Safety Evaluation Report

Related to the License Renewal of R.E. Ginna Nuclear Power Plant

Docket No. 50-244

Rochester Gas & Electric Corporation

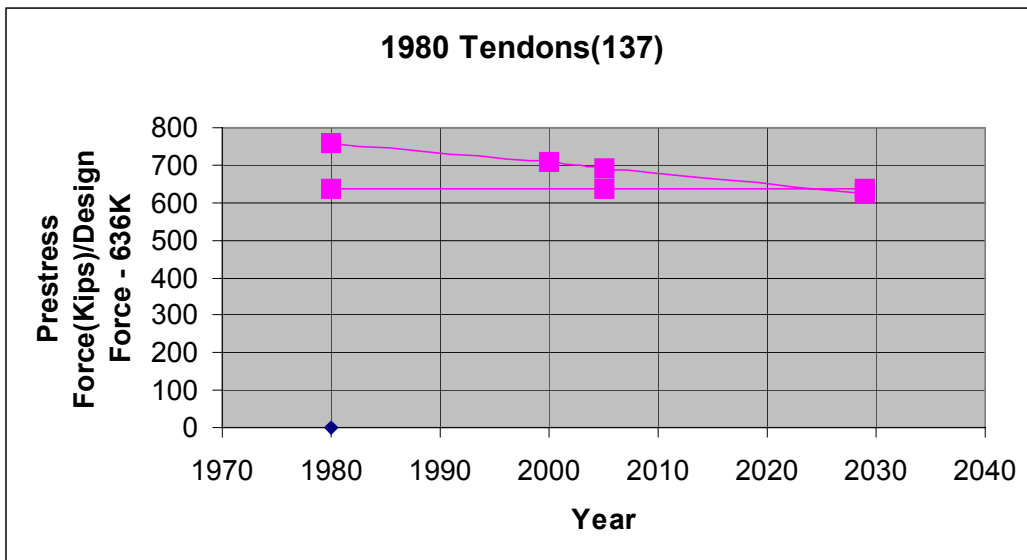
In addition to the review of Section 4.5 of the LRA, the staff reviewed the relevant information in Sections 2.4.1, 3.6, B2.1.3, B3.3, and Section 4.7.4 of the LRA. In the earlier years (1979–1980), the applicant had experienced lower prestressing forces than the minimum required value (MRV) estimated at 40 years. In order to understand the present state of the prestressing forces in the Ginna containment, the staff requested that the applicant provide the following additional information in RAI 4.5-1:

1. For the 137 tendons which were retensioned in 1980, the applicant was requested to provide the predicted lower limit line, MRV expected in 2005 and at 60 years (if not retensioned in 2005), a trend line for this group of tendons, and prestressing force values as points above and below the trend line measured during prior inspections.
2. The applicant was requested to provide the same information for the remaining 23 tendons for the inspections performed after the 1969 retensioning.

In response, the applicant provided the following information:

- a) Based on the available test information for this set of 137 tendons that were retensioned in 1980, the below graph shows the trend line from 1980 projected through 2005, and out to 2029. The graph also includes a constant line at 636 kips, which is the minimum design prestress force.
